R22

SERVICE BULLETIN SB-92

SUBJECT: Tail Rotor Pedal Retaining Clips

VIEW LOOKING FORWARD

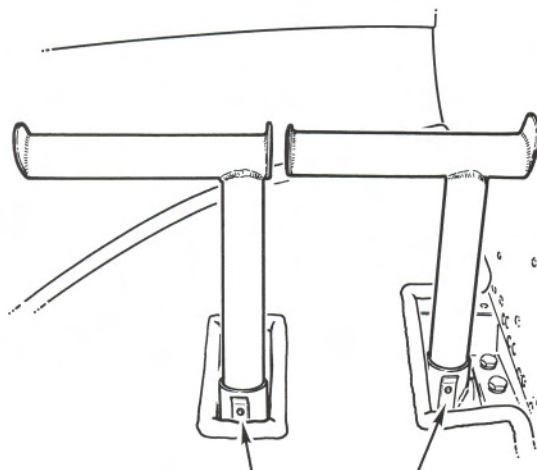
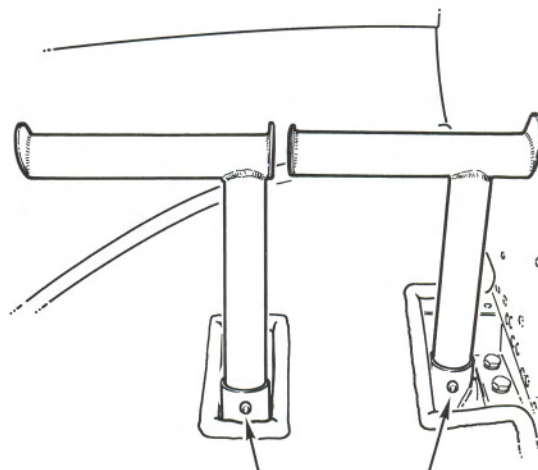
BACKGROUND: RHC has received reports of worn A795-1 retaining clips allowing removable pedals to vibrate out of position and interfere with pedal movement. This bulletin requires replacement of all external A795-1 retaining clips with push-button type A795-4 locking pins.

**EXTERNAL A795-1
RETAINING CLIPS
(Require replacement)**

1. Order KI-81 kit from RHC Customer Service.
2. Replace retaining clips per kit instructions.

**PUSH-BUTTON TYPE
A795-4 LOCKING PINS
(Acceptable)**
